# **Investigation and Mitigation Report on Incident Occurring at**

**125 CROWN TERRACE**

**Tom C. Hui, S.E., C.B.O.**

Re: 125 Crown Terrace – SFDBI Structural Advisory Committee  
**Review of Engineering Report in Response to Complaints Nos. 201343501 and 201343861**

# MITIGATION PLAN

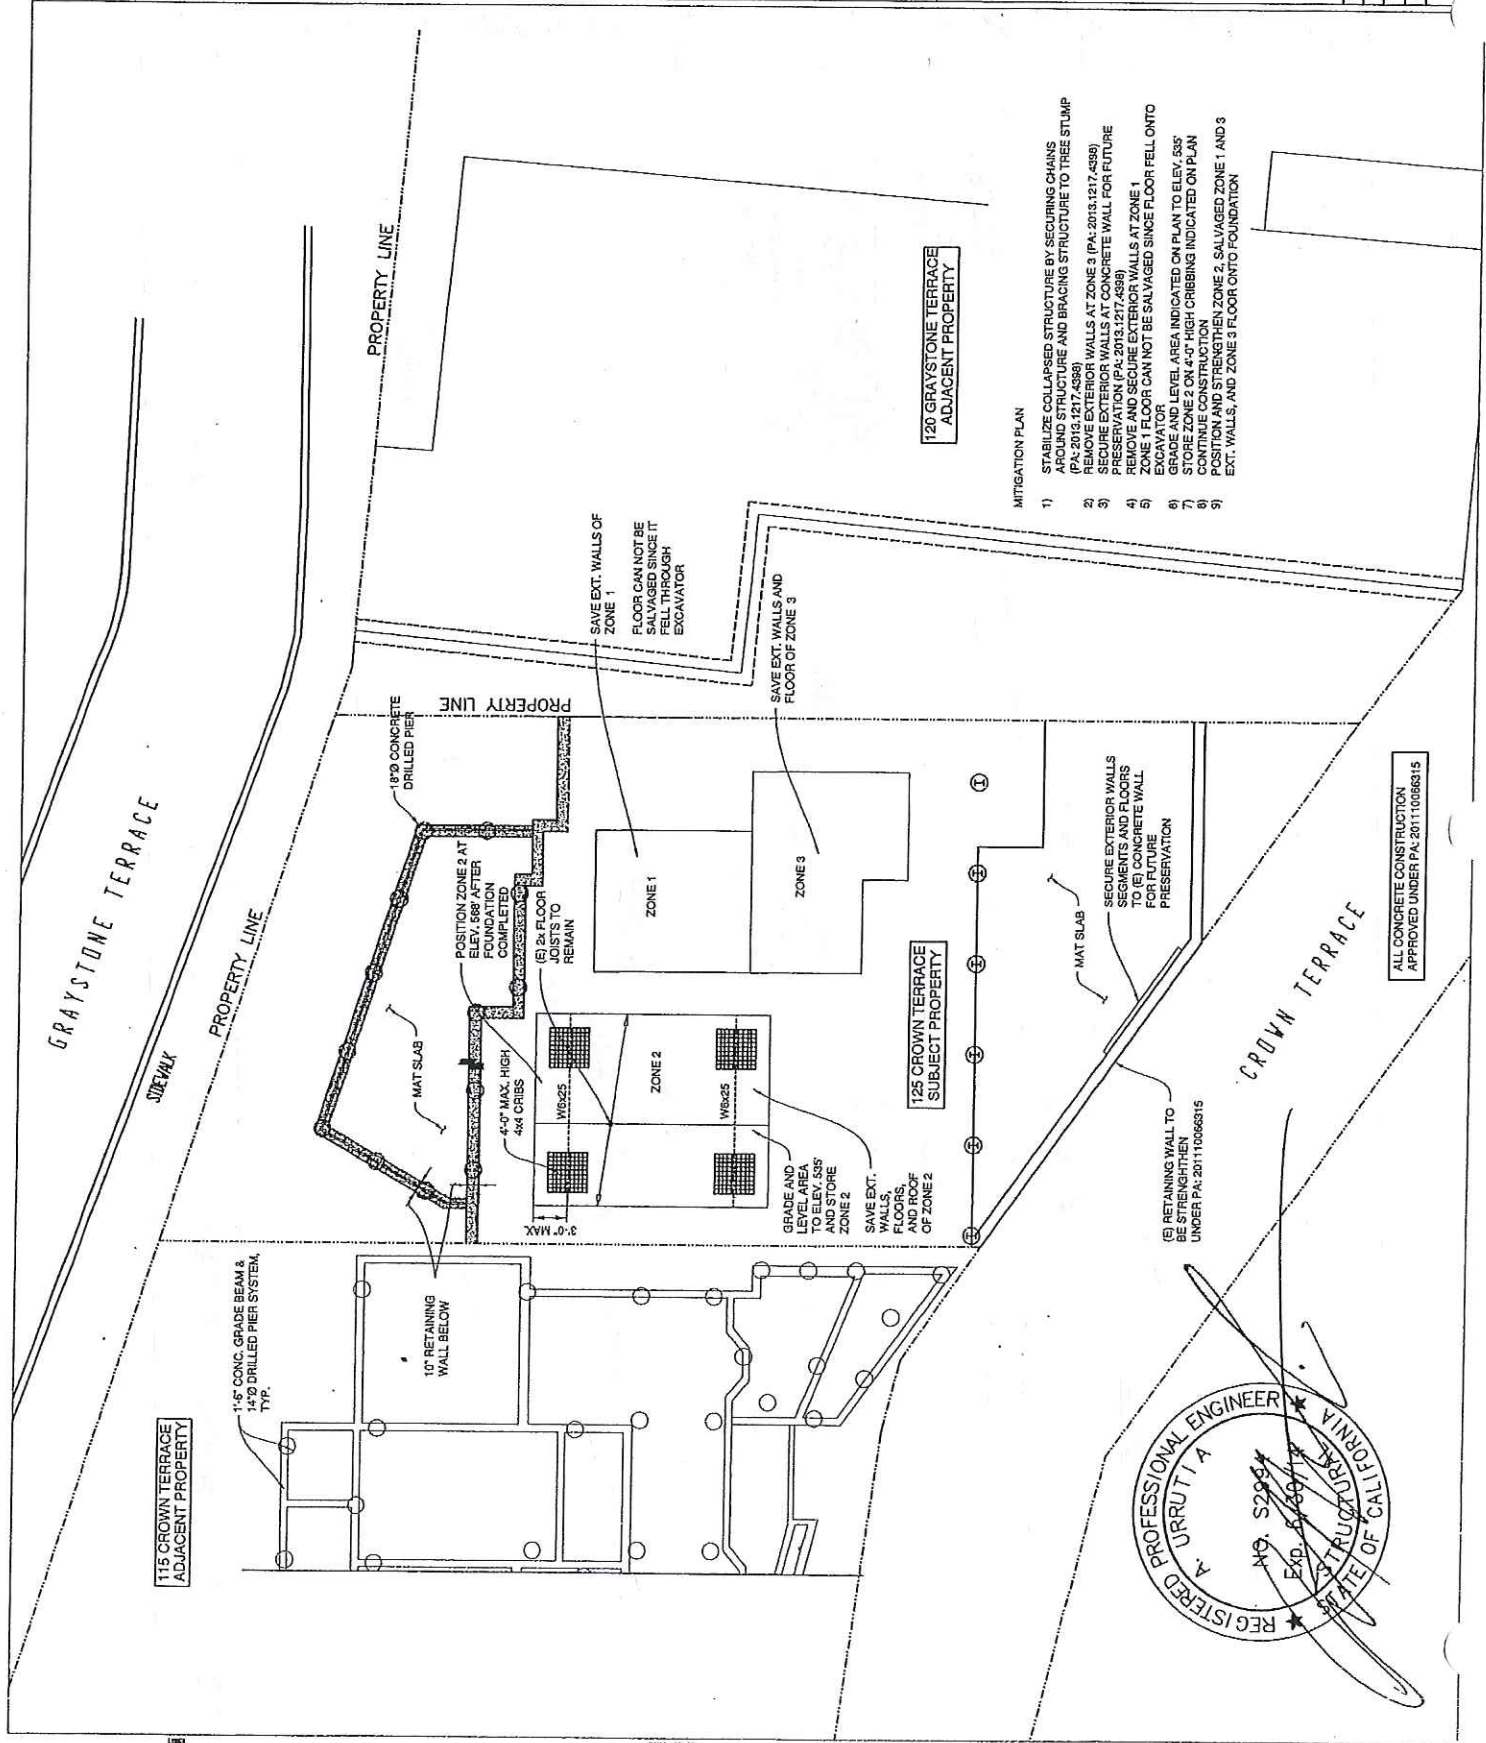
6. The Mitigation Plan sheet indicates that Building Zone 2 will be relocated at Elevation 535' on W6 beams supported on 4'-0" high cribs upon completion of grading and leveling. Verify adequacy of W6 shoring beams and cribs shown and of existing framing to span between W6 beams. Clarify how Zone 2 will be supported during grading and leveling operations.

7. The Mitigation Plan sheet also indicates that Building Zone 2 is to be raised to Elevation 568' after completion of the foundation. Confirm if Zones 1 and 3 are to be raised to this level. Will an intermediate shoring plan showing temporary supports at Elevation 568' be required? Submit such a plan if so required with all required documentation.
8. The narrative discusses the addition of a shear wall at the northernmost building segment. This shear wall is not shown on any of the drawings in the report. Clarify intent of shear wall. Is this shear wall designed as a permanent wall for the completed building or is it designed for the temporary condition? Verify adequacy of shear wall design if so required.

# COLLAPSED TEMP SHORING PLAN

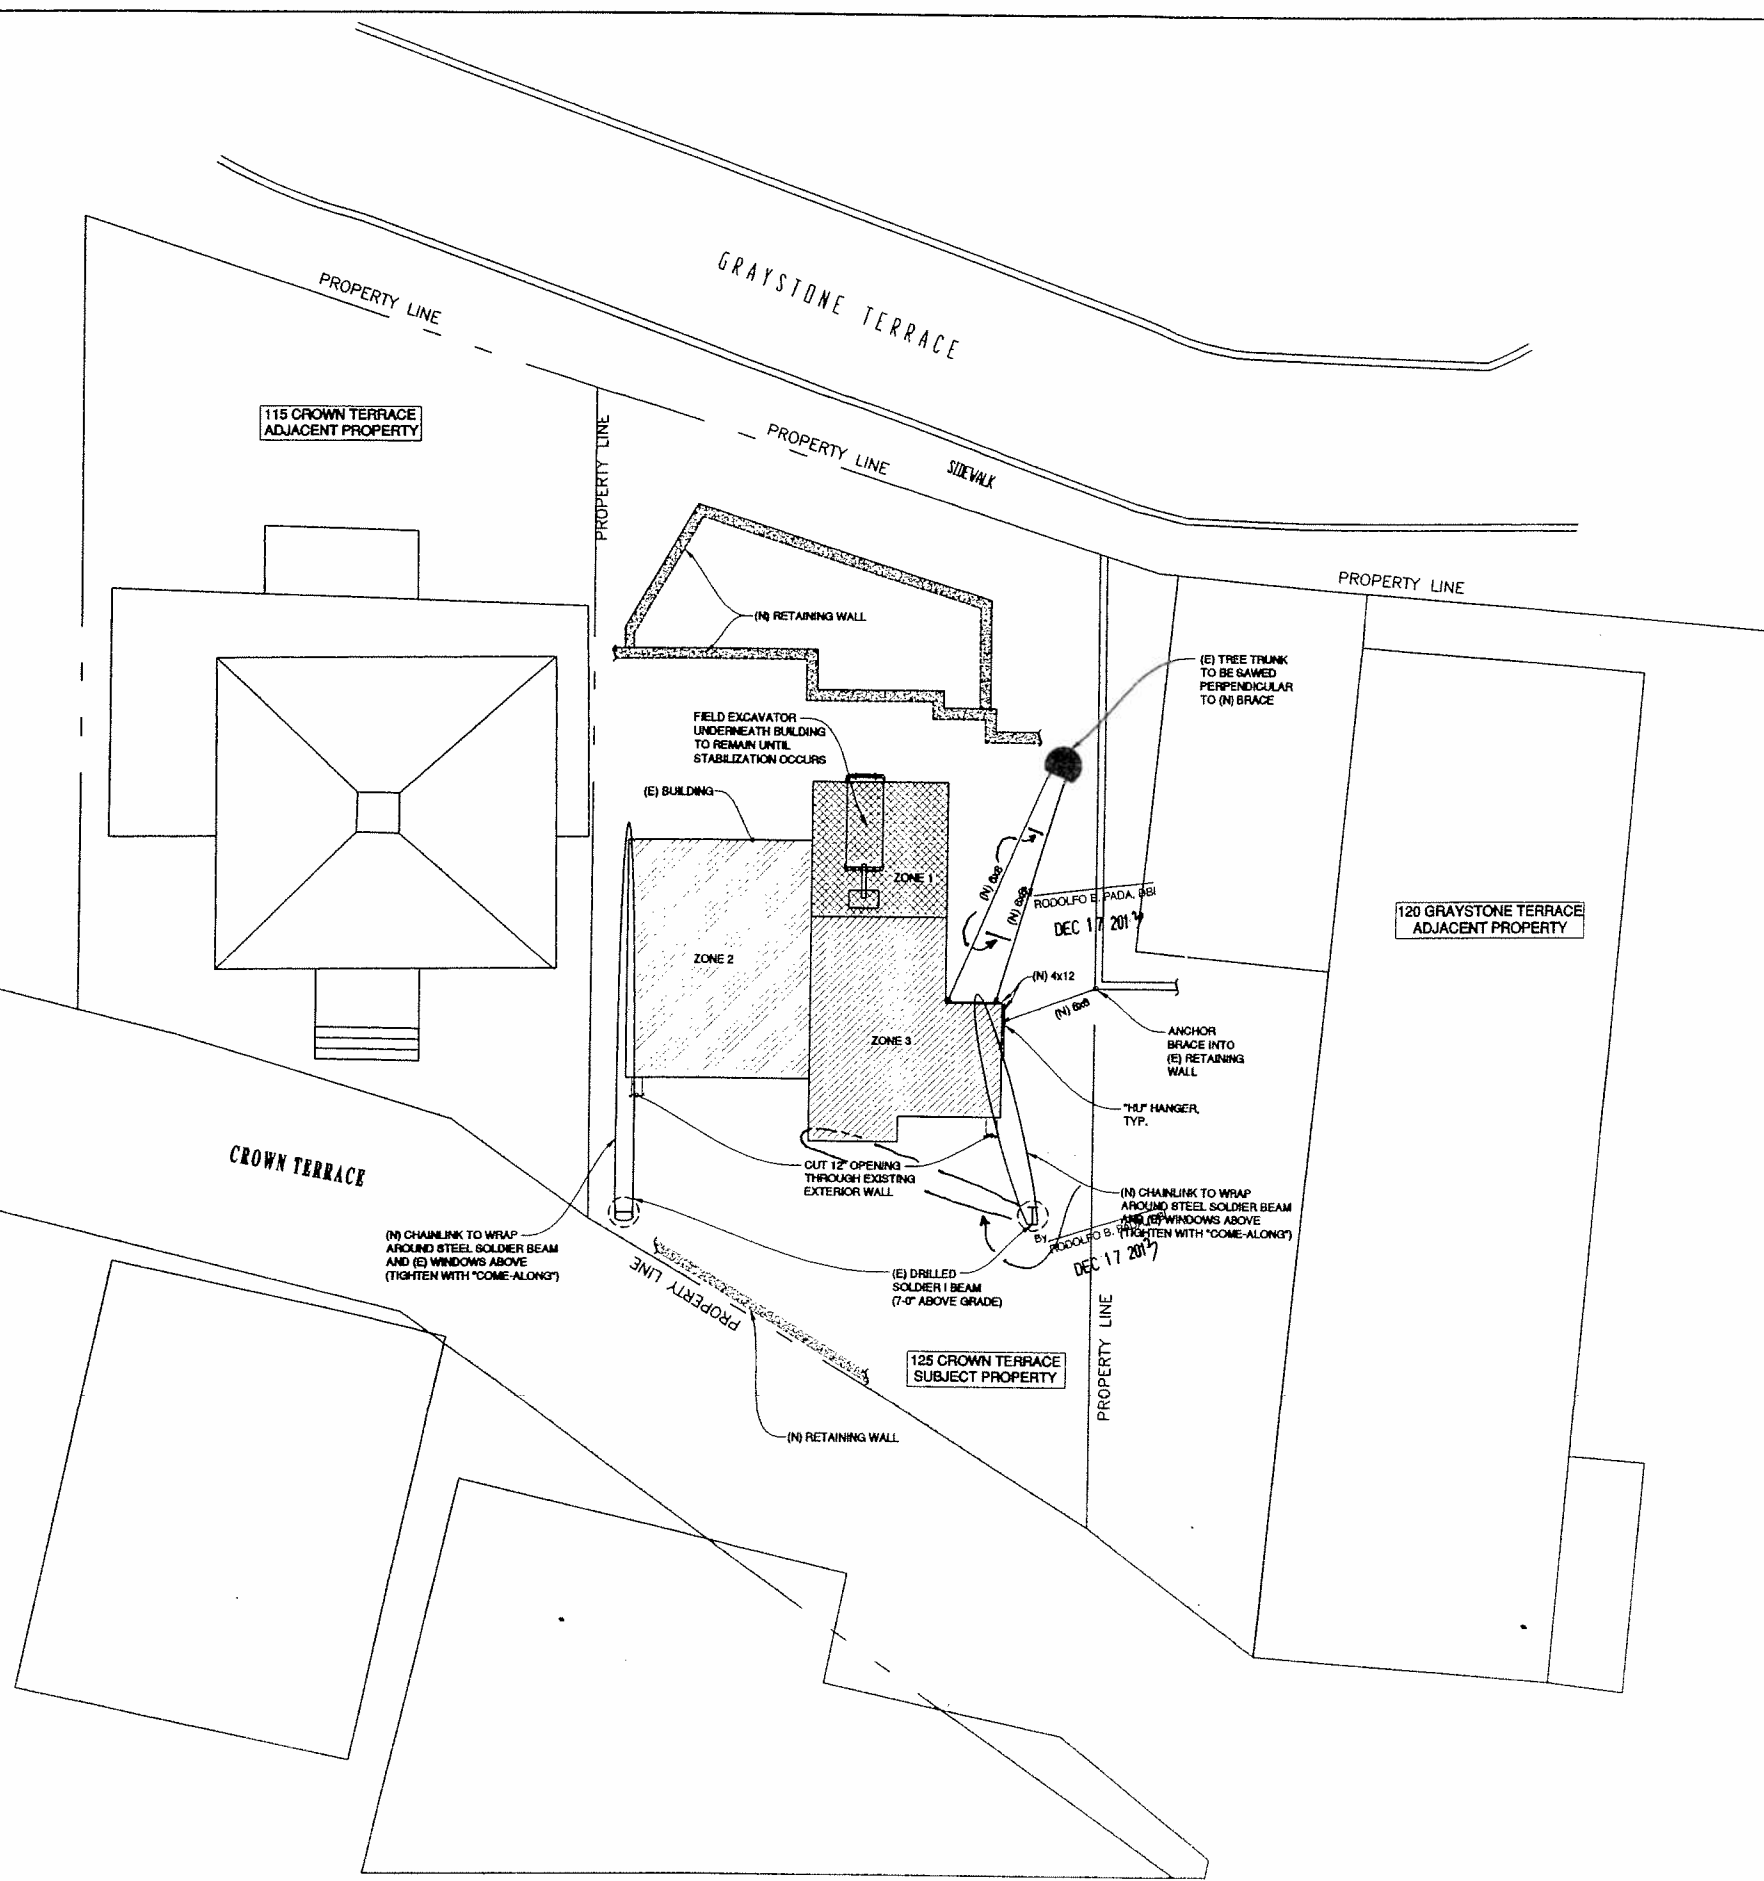
1. The Collapsed Temporary Shoring Plan shows a total of three cribbing towers, a future tower, and two shoring beams. The condition shown on plan differs from the narrative, which indicated three towers along the north side of the building and two towers with a shoring beam along the south side. Please clarify this discrepancy.

EXISTING SITE PLAN  
SEQUENCE OF EMERGENCY SHORING  
& STABILIZATION OF (E) BUILDING

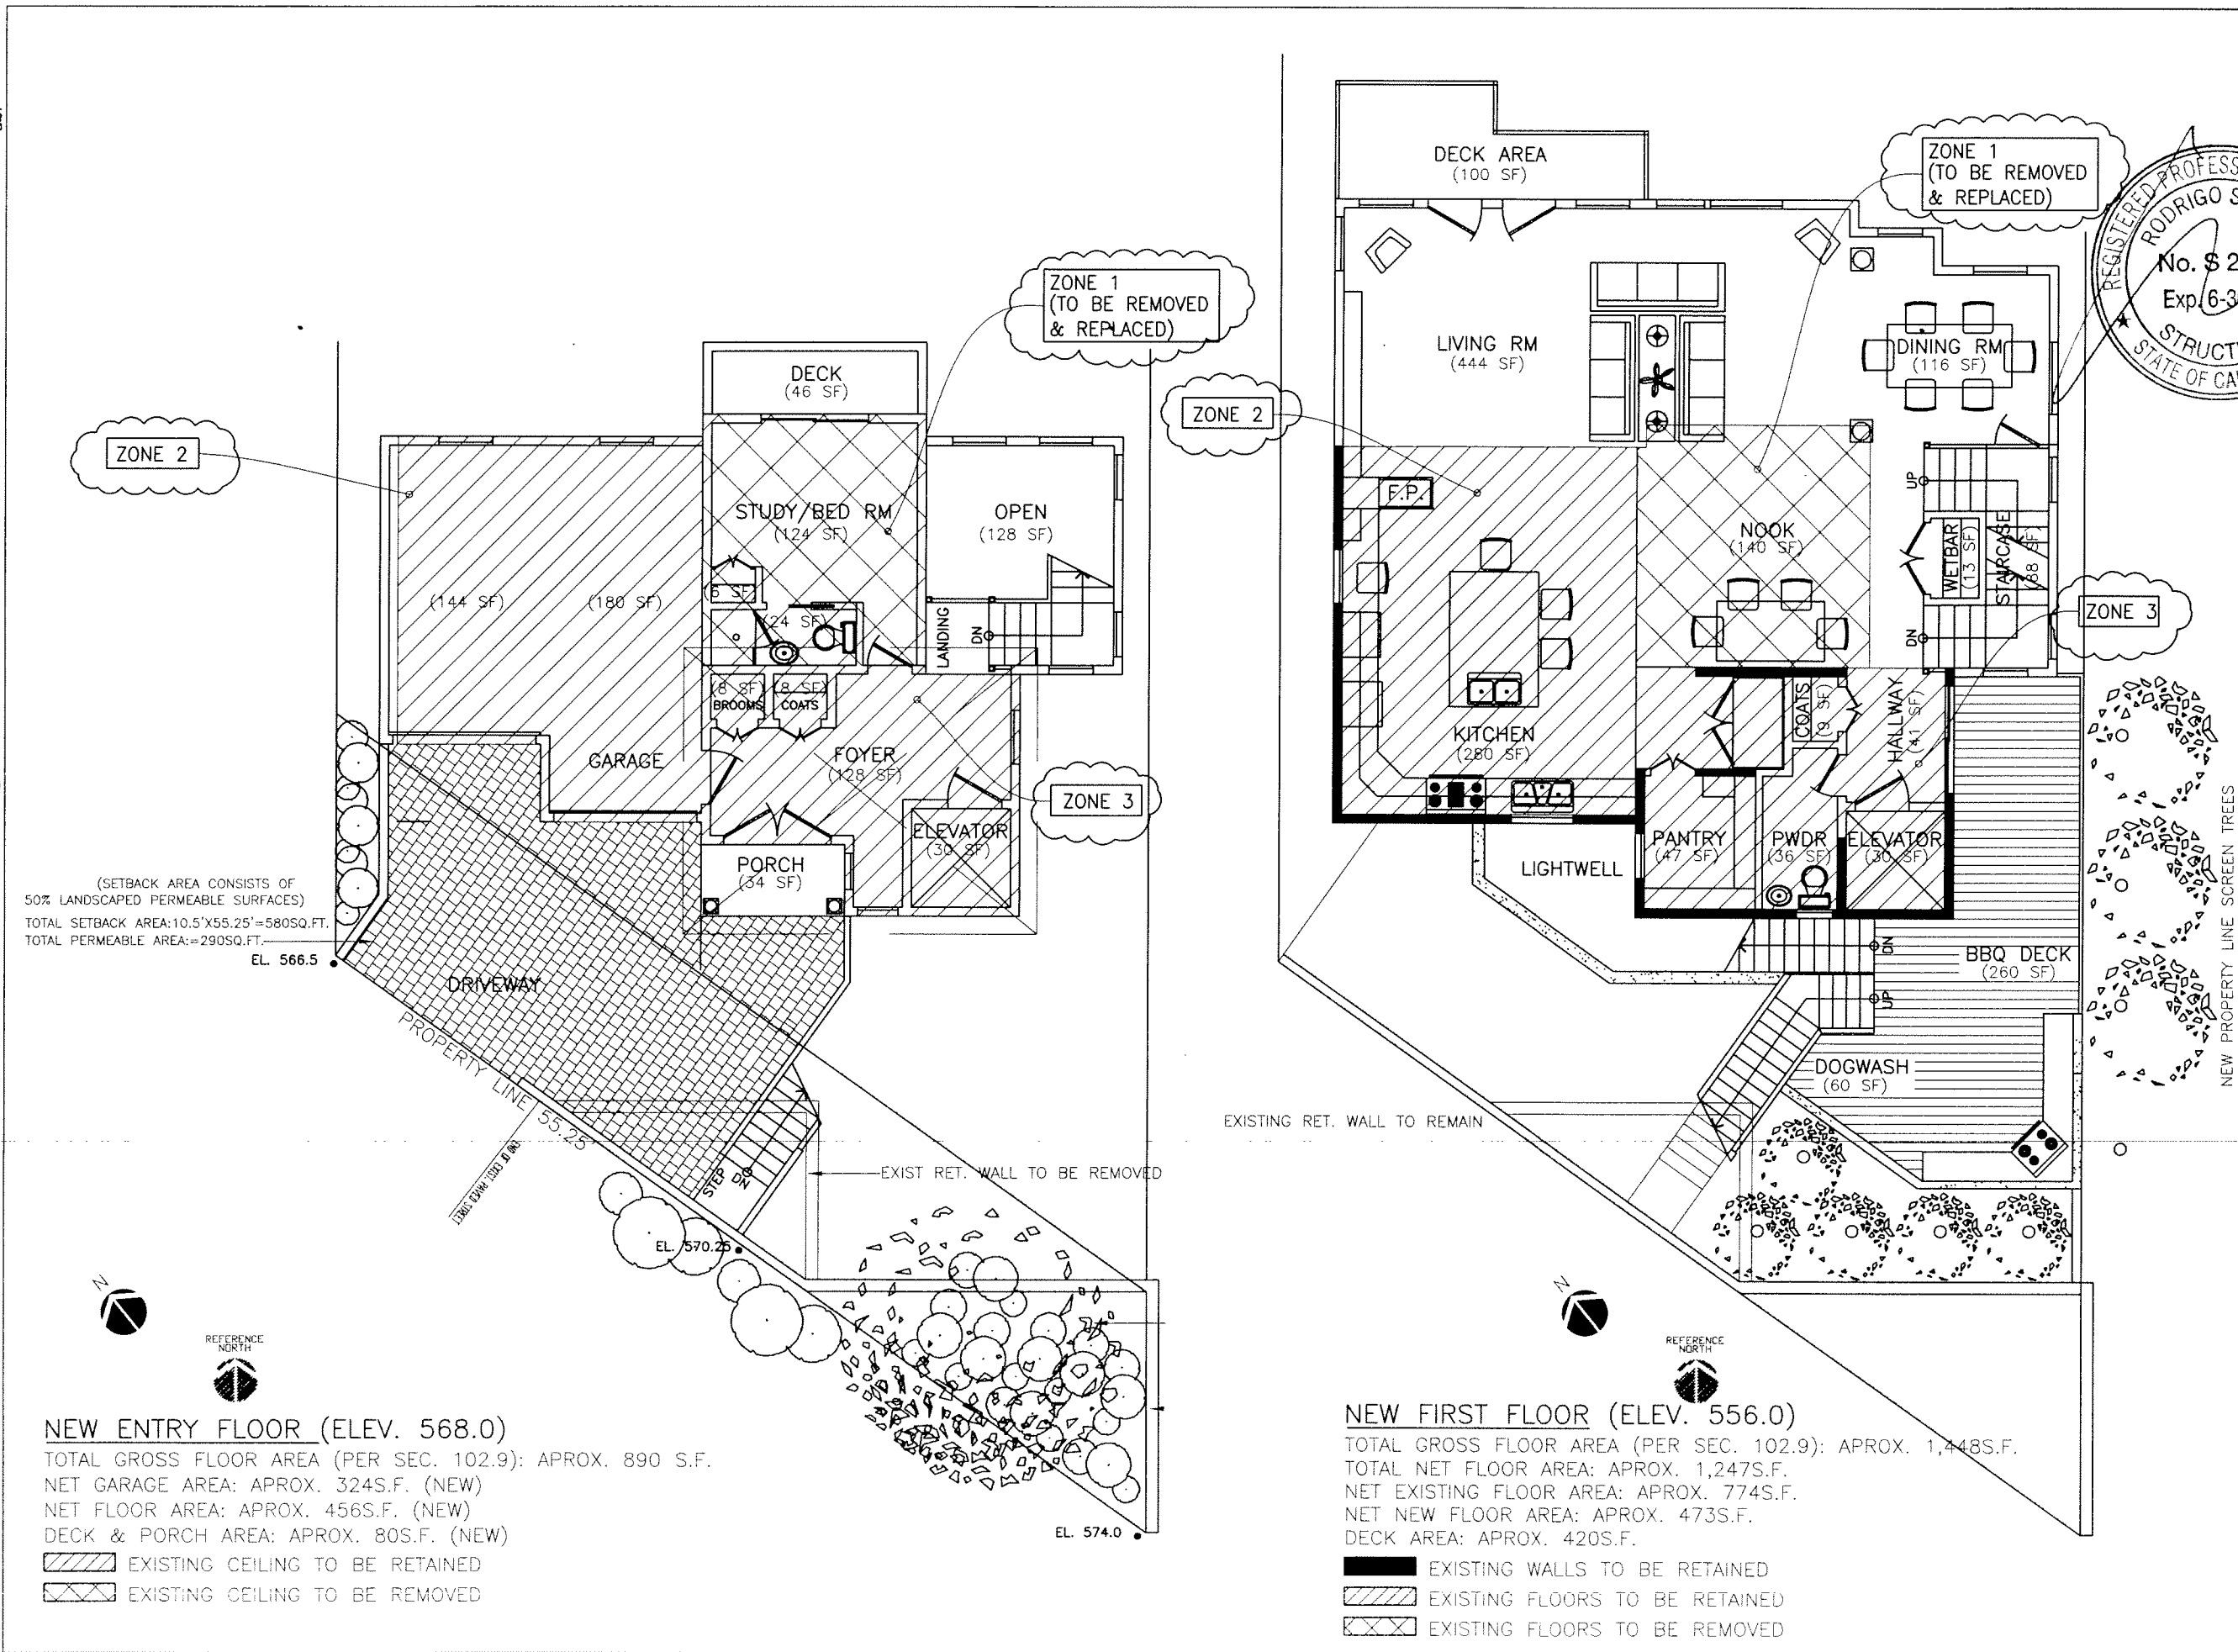
2. The Emergency Shoring Plan shows that the existing tree trunk near the southeast corner of the lot will be shaped to accept 6x8 wood members to temporarily brace Building Zone 3. It is suggested that if possible, additional blocks/shims be placed between the tree trunk and the new adjacent retaining wall in the event the tree trunk is not stable. Verify adequacy of 6x8 wood members given their apparent long unbraced length and connections to the existing building. Verify that 6x8 wood members are rigidly attached at floor level to the existing building.

4. Clarify if additional temporary support is required for the south side of Building Zone 2 (temporary braces, chains, etc.).
5. Verify adequacy of existing soldier beams to resist additional loads from downhill building zones due to proposed chain restraints. Are chains themselves adequate for such loads?
